INVITATION TO BID
BID NO. 9934
TROY SCHOOL DISTRICT 2022 PAVING PROGRAM

This Addendum is issued as modifications to the RFP previously issued to provide clarifications to the scope of work. This Addendum supersedes the original RFP. This along with the RFP becomes the bid documents.

1. For questions e-mail purchasingoffice@troy.k12.mi.us or through Buildingconnected.com.
2. Addendum #1 dated January 18, 2022 as prepared by PEA Group. (Attached)
3. Revise Bid Package, Proposal Form. Revise PF-2. Add Alternate #2 for Facilities and Operations Building. (Attached)
4. Pre-Bid Meeting Sign In Sheet dated January 18, 2022. (Attached)

C-3.0

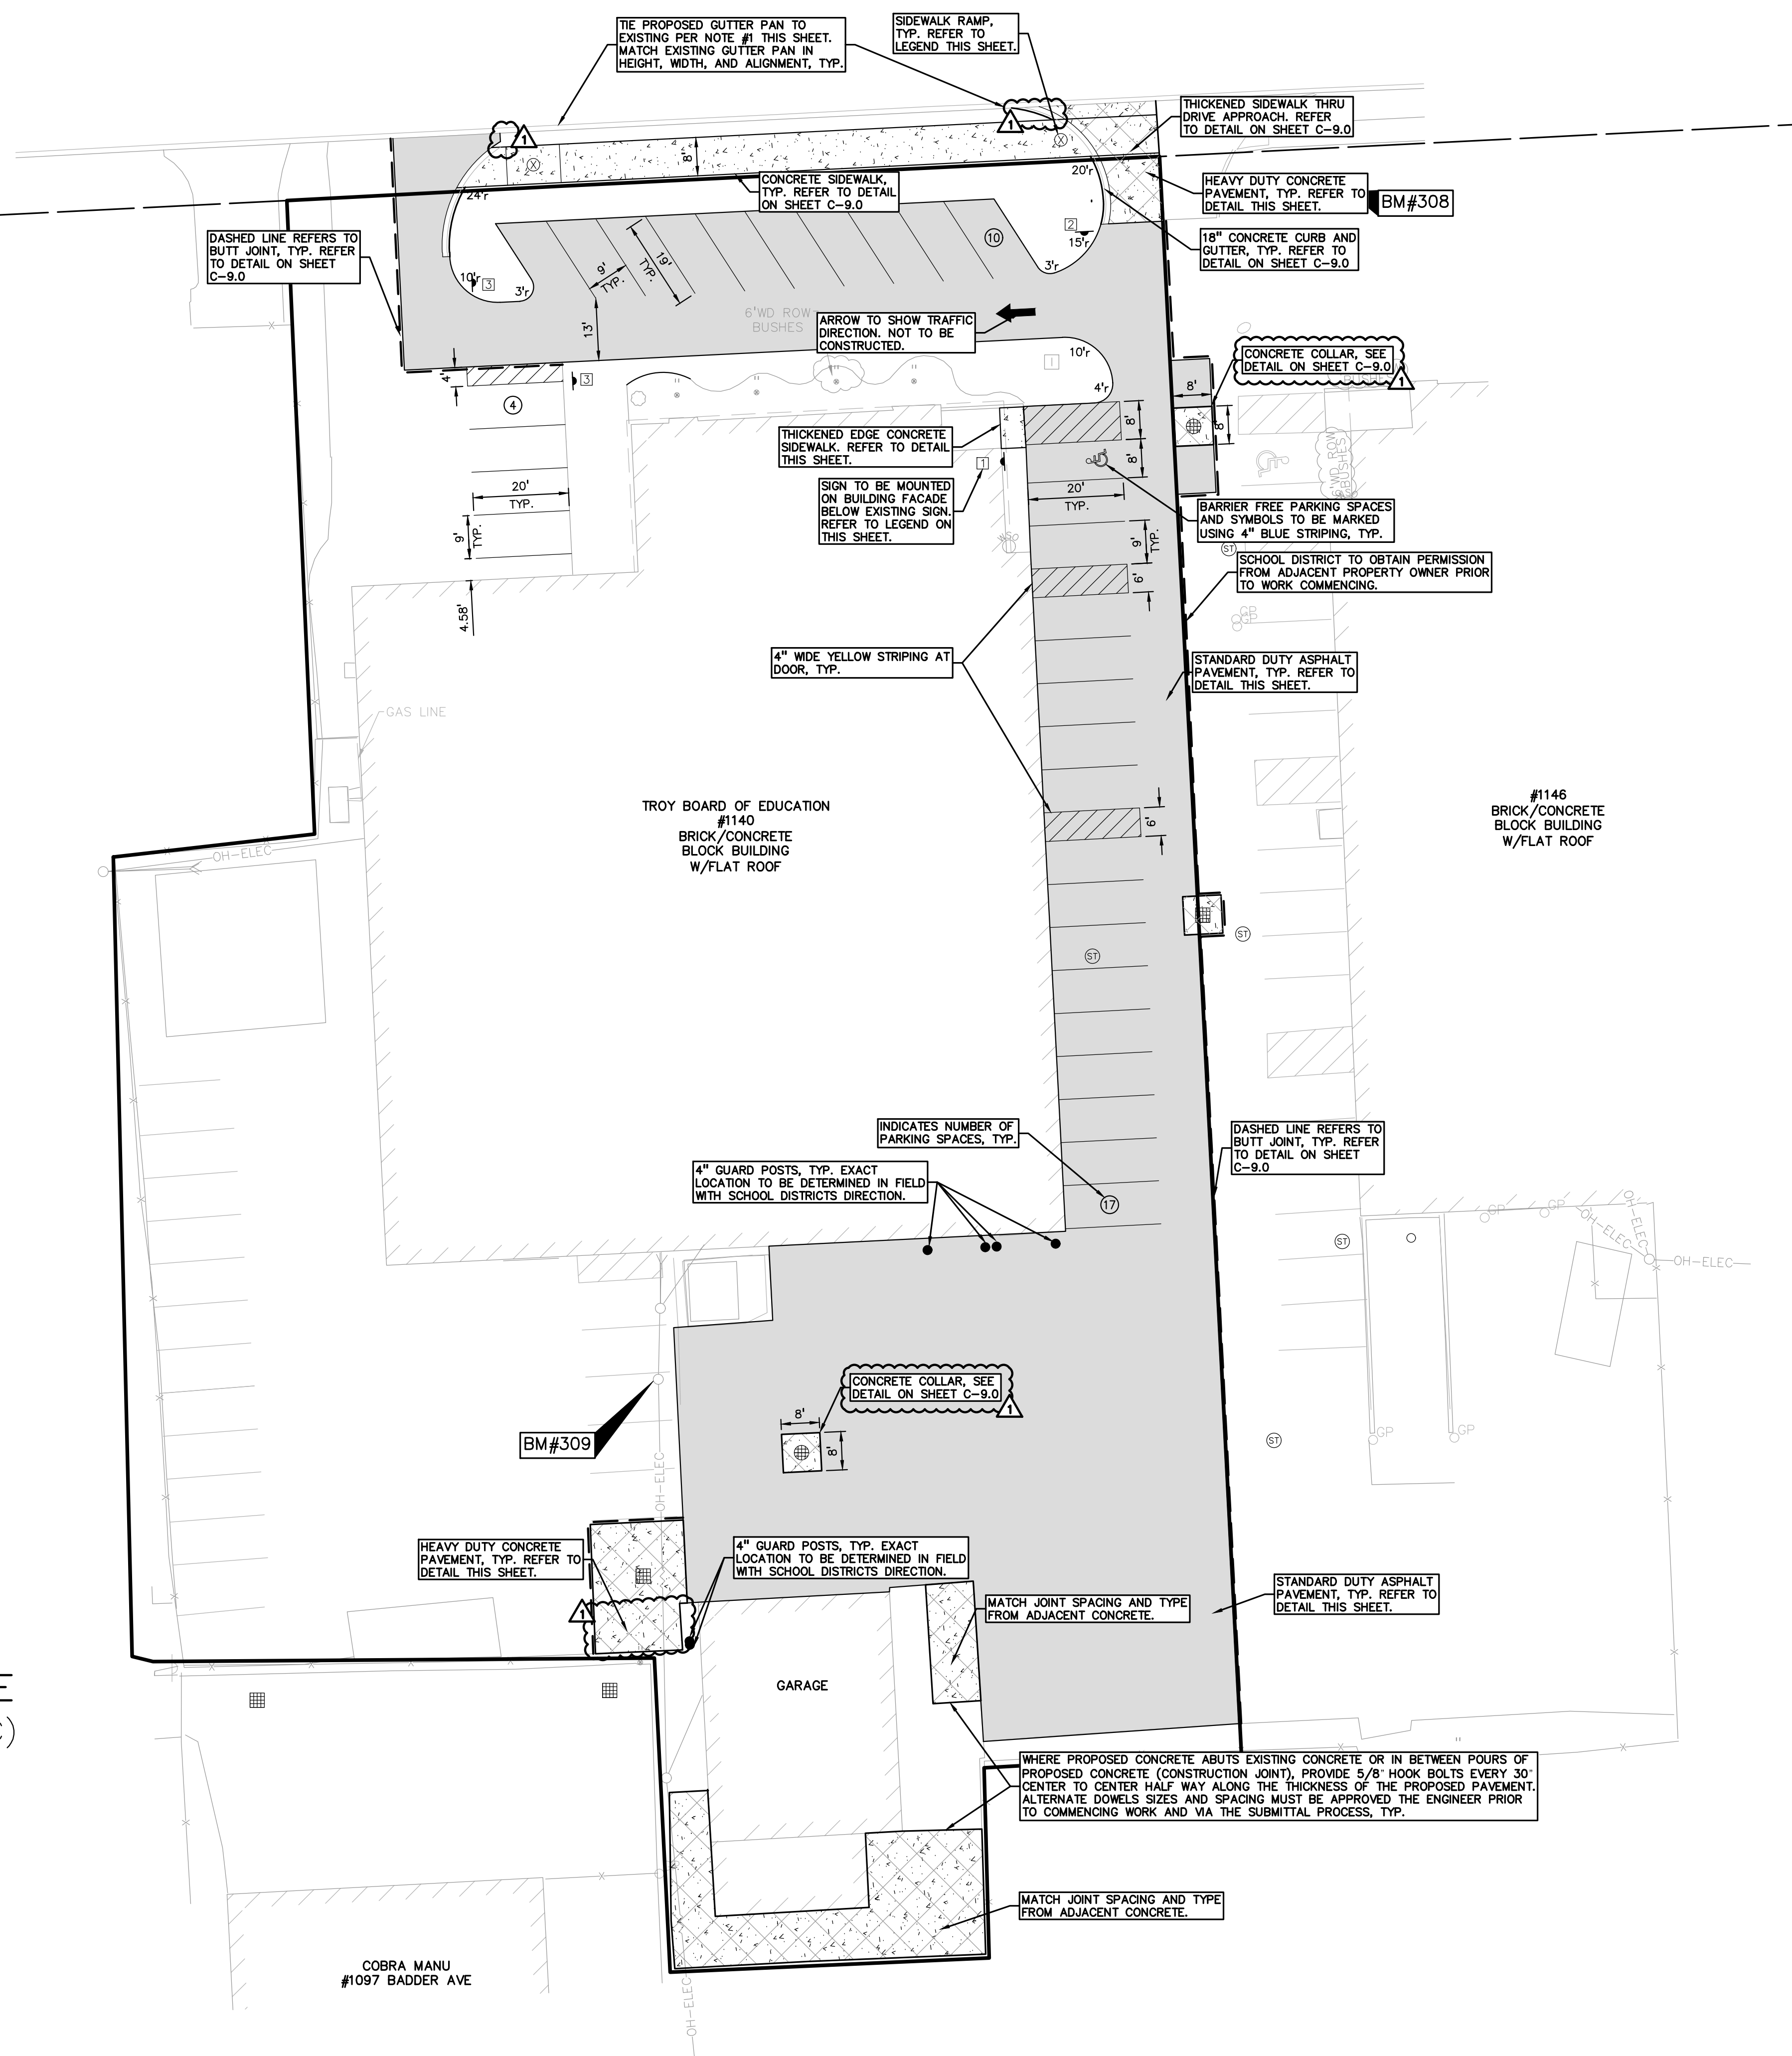
- b. Sheet C-3.0
 - 1. The call outs for a new MDOT Detail M gutter pan along Rankin Drive have been removed. The proposed pavement for the drive approaches will butt up against the existing pavement per the City of Troy Standards including any thickened edges and/or expansion joint or tie bars for the concrete pavement as directed by the city inspector.

- 4. The area pavement adjacent to the northwest corner of the garage has been revised from heavy duty asphalt to heavy duty concrete and the quantity table has been updated accordingly.

- 5. A note has been added to the plan sheet to reflect that this site will be a two phased project to allow Owner access and the actual phasing will be determined at a later time.

C-2.2

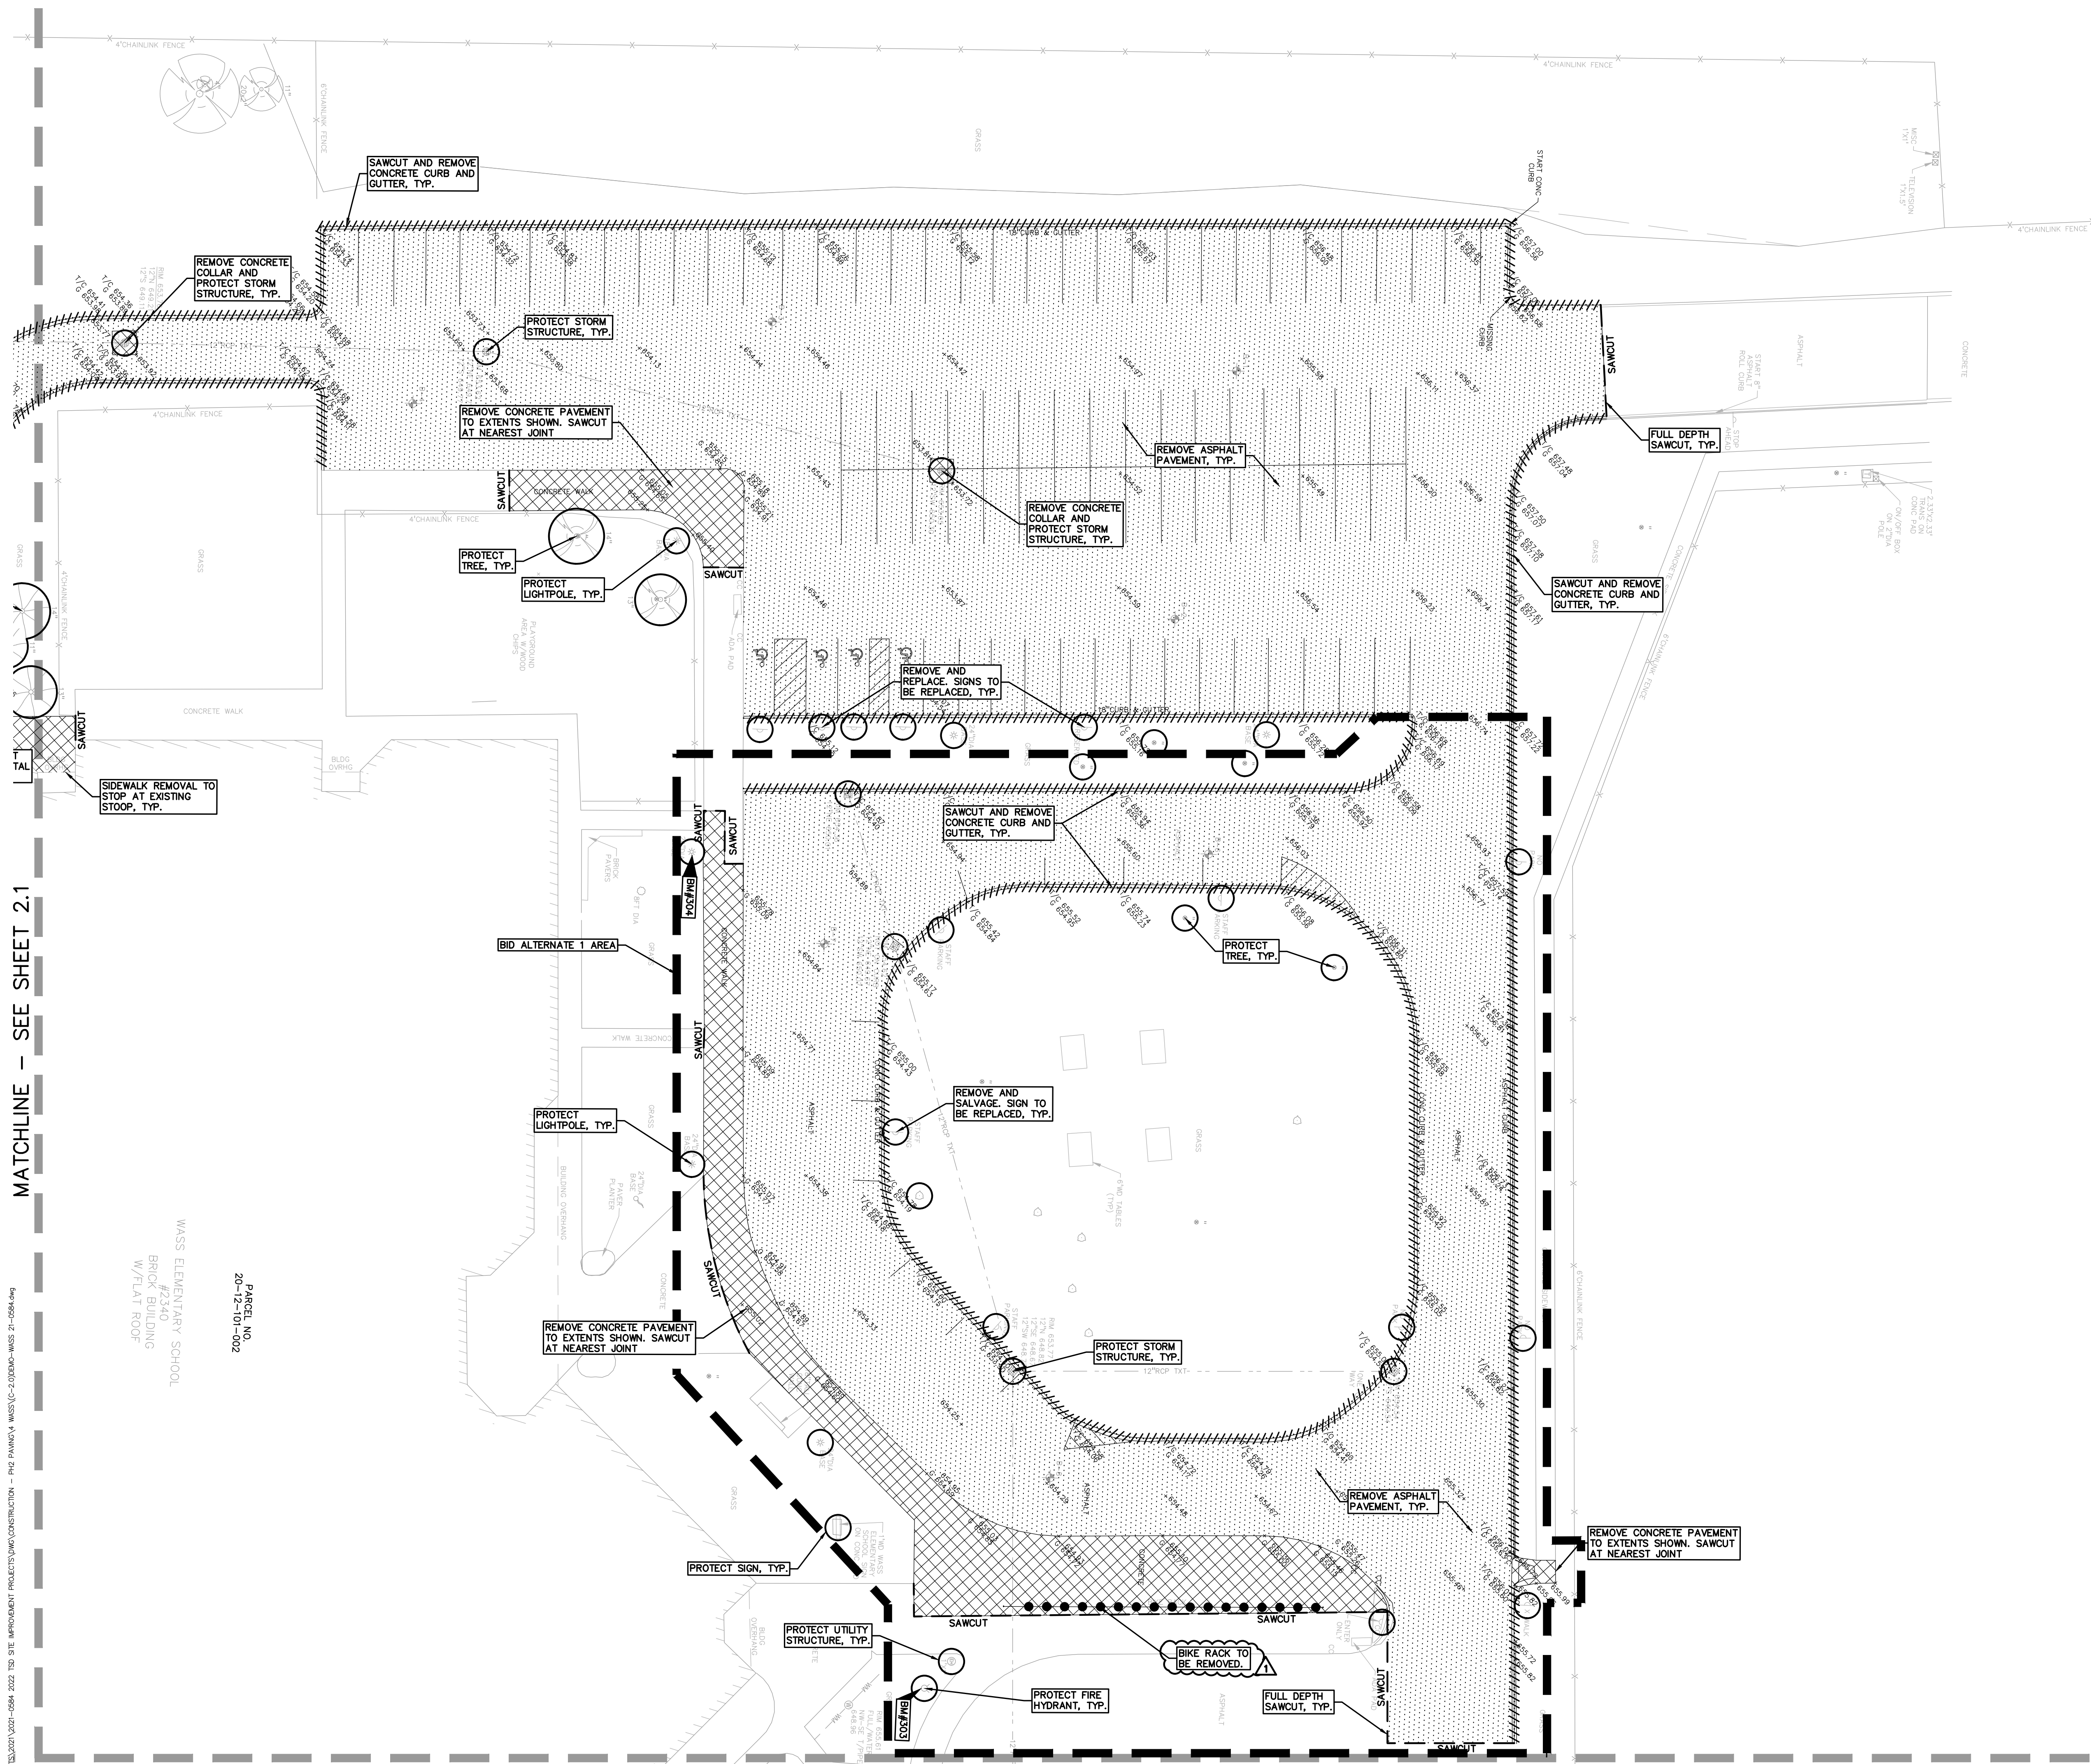
- b. Sheet C-2.2
 - 1. The call out for the bike rack has been updated to reflect that the rack is to be removed and disposed of versus salvaged.
 - c. Sheet C-3.1
